Date: April 18, 2022
To: All Prospective Bidders
From: Sam Li
Deputy Director for Purchasing
Re: Addendum Number 4
RFQ C1543 – CoEd Residence Hall Bathroom Renovations Floors 9 - 10

PROJECT:
CO-ED RESIDENCE HALL BATHROOM RENOVATIONS - 9TH-10TH FLOORS
230 WEST 27TH ST
NEW YORK NY 10001

DRAWING TITLE:
9TH FLOOR MECHANICAL PART
PLANS - DEMOLITION AND NEW WORK

10TH FLOOR EAST MECHANICAL PART - NEW WORK

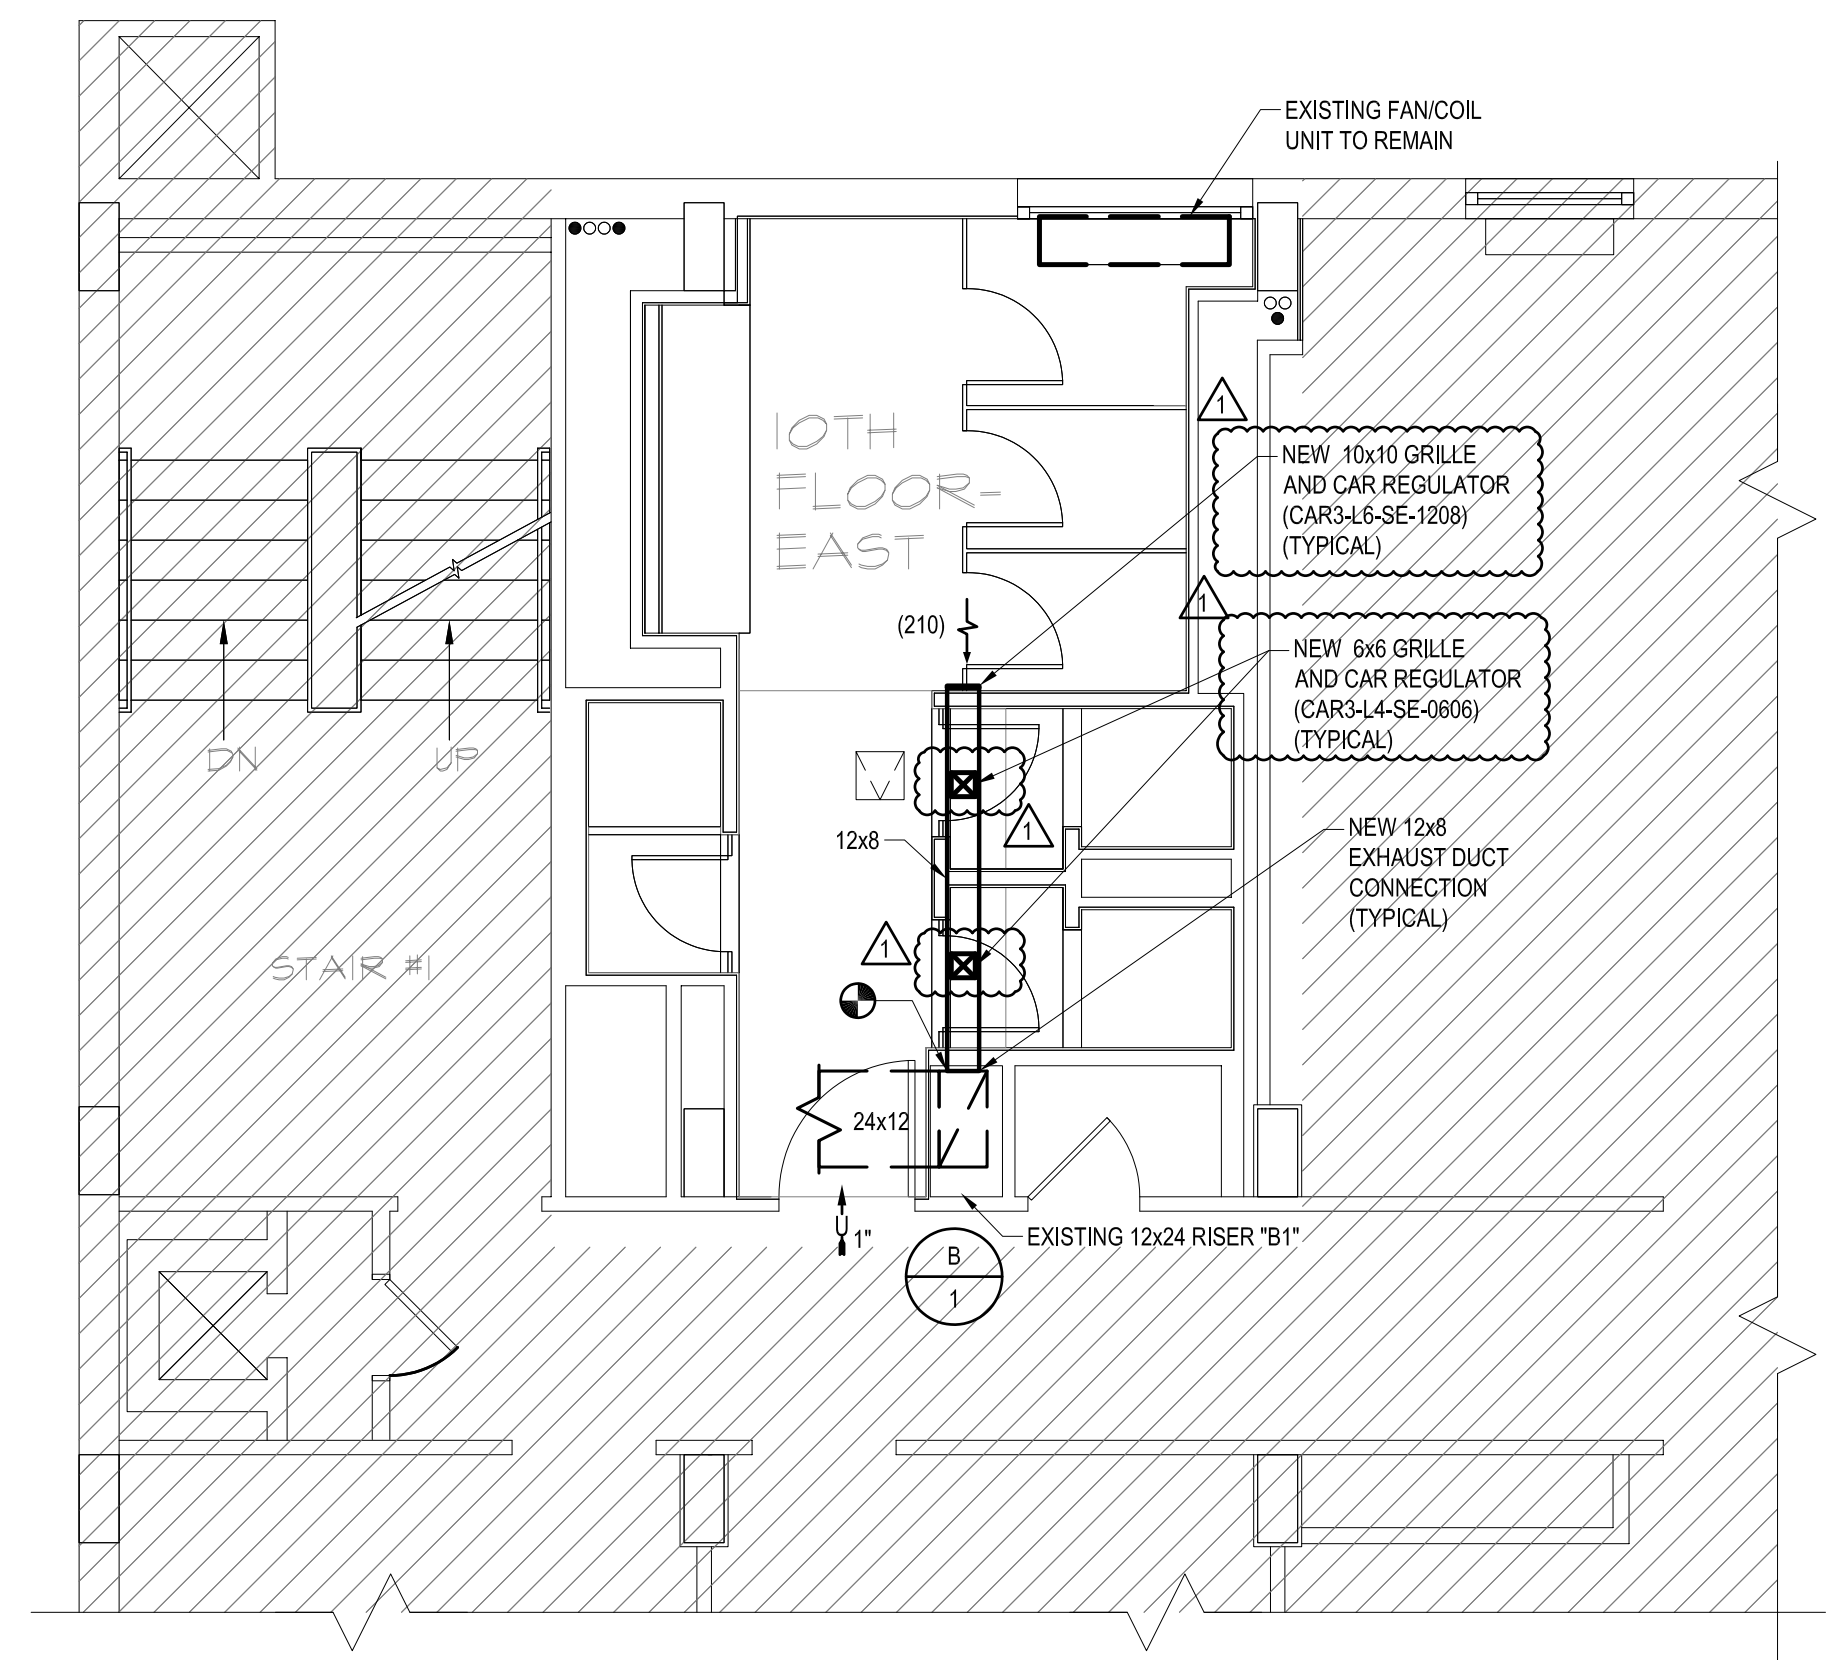
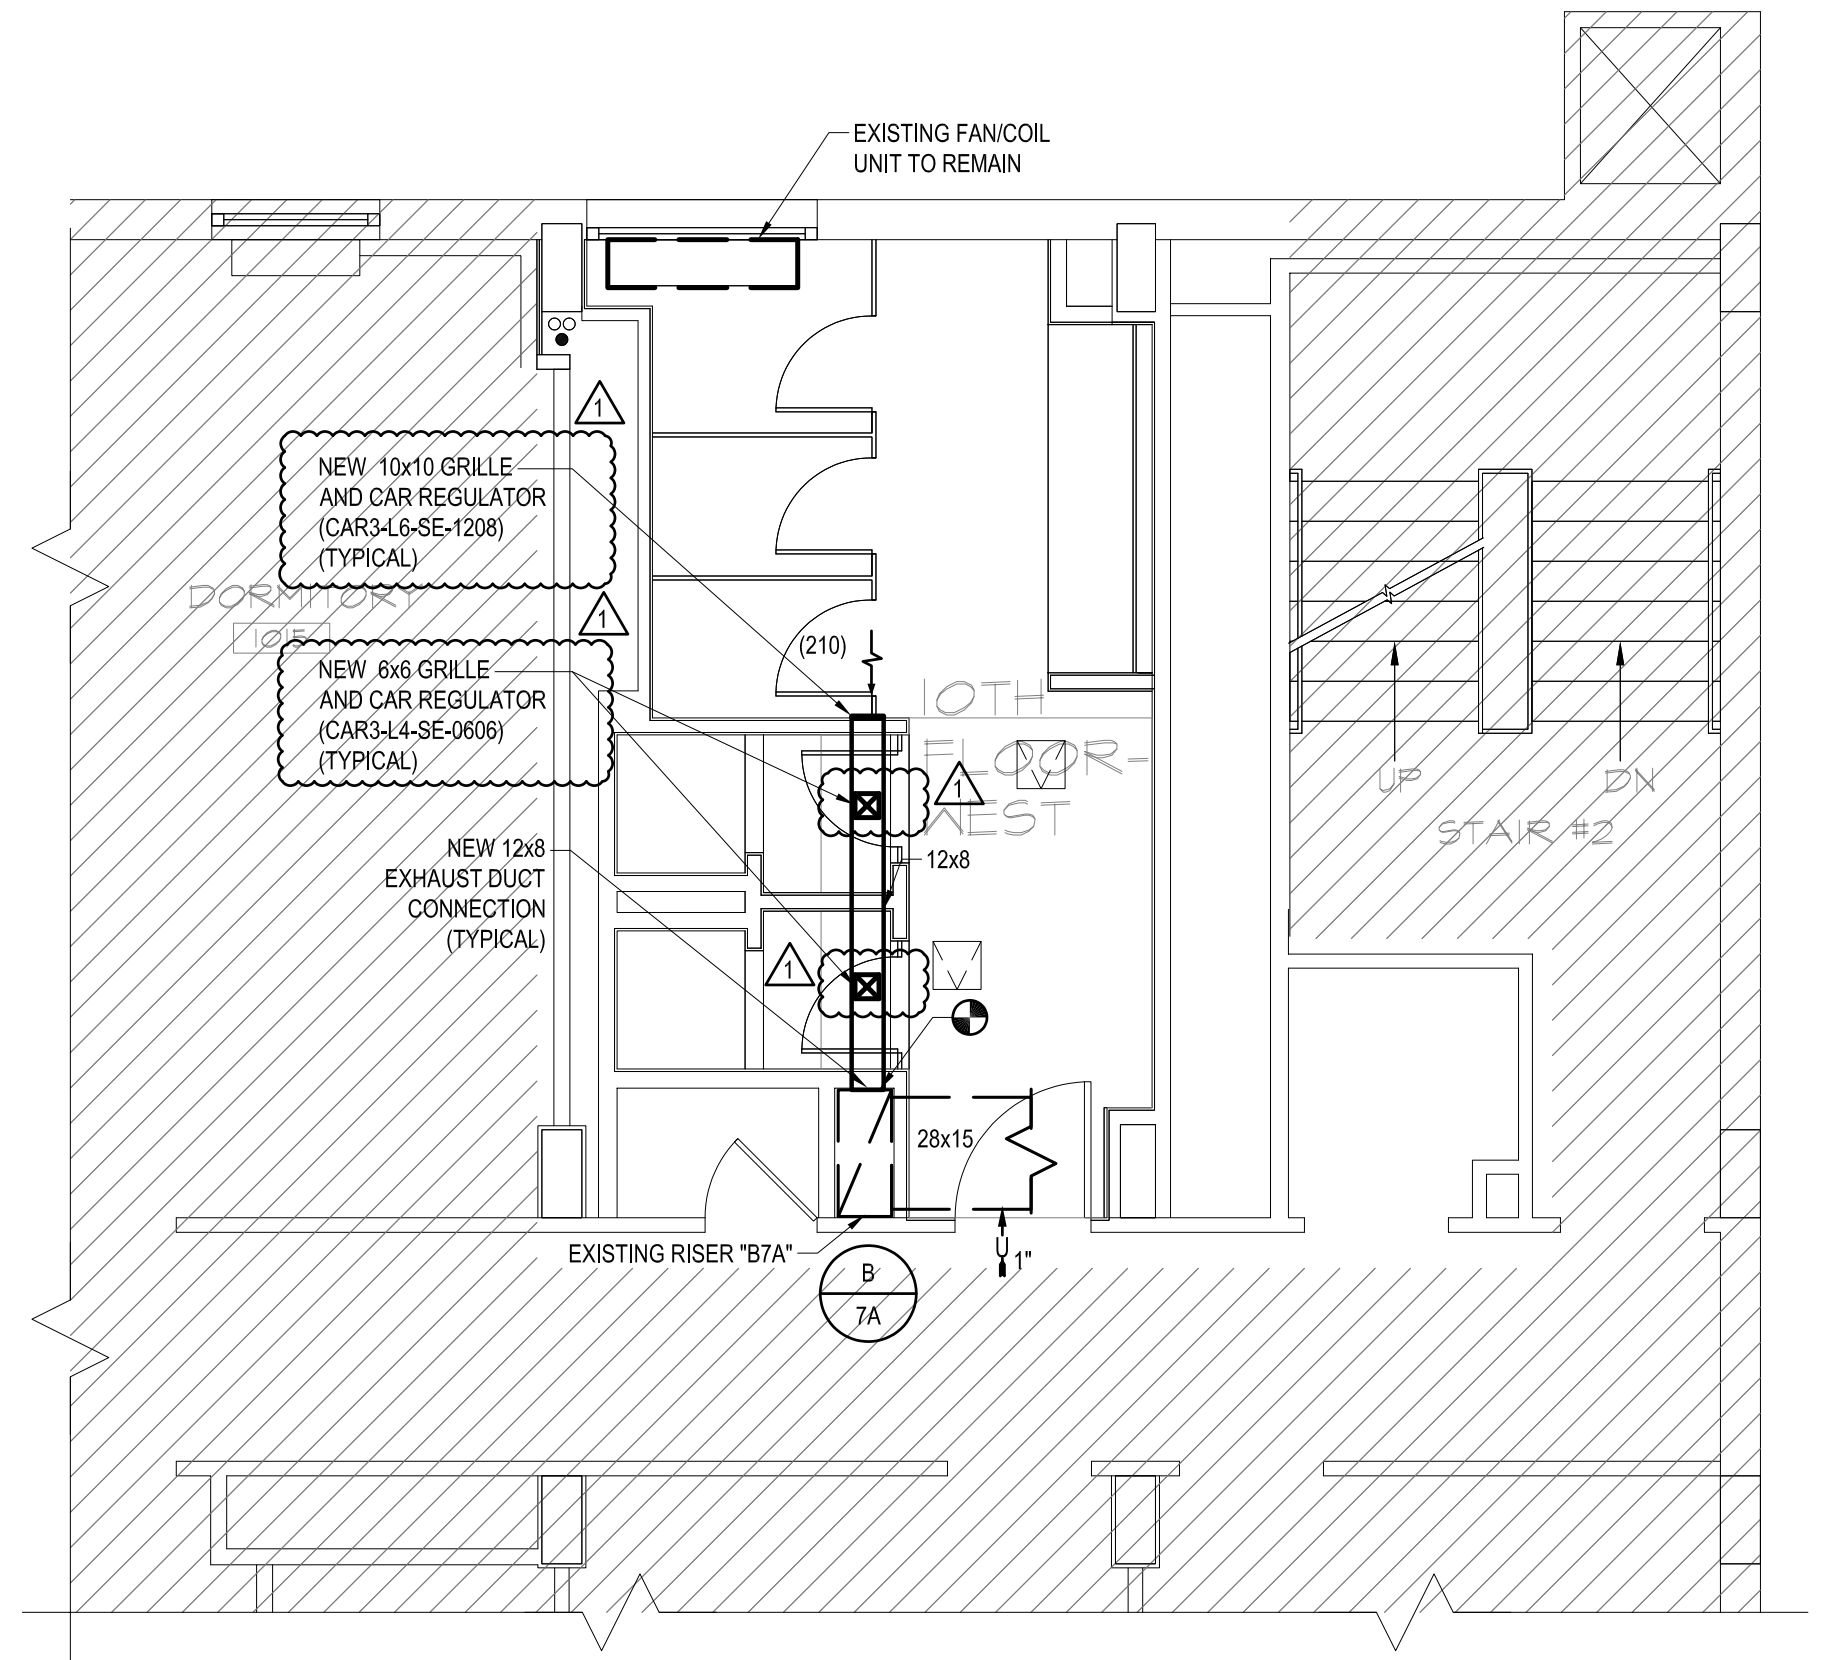
- NEW WORK NOTES:**
1. INSTALL NEW EXHAUST DUCT AND EXHAUST GRILLE AS SHOWN. CONNECT NEW DUCT TO EXISTING RISER. PROVIDE CABLE OPERATED DAMPER. DAMPER SHALL BE OPERABLE THROUGH THE DIFFUSER GRILLE.
 2. EXHAUST GRILLE SHALL BE CAR REGULATOR AS MANUFACTURED BY "ALDES" MODEL CAR3-Lx-SE-xxxx. COORDINATE THE LOCATION OF THE GRILLES WITH THE ARCHITECTURAL DRAWINGS.
 3. TOILET DOOR SHALL BE 1" UNDERCUT.
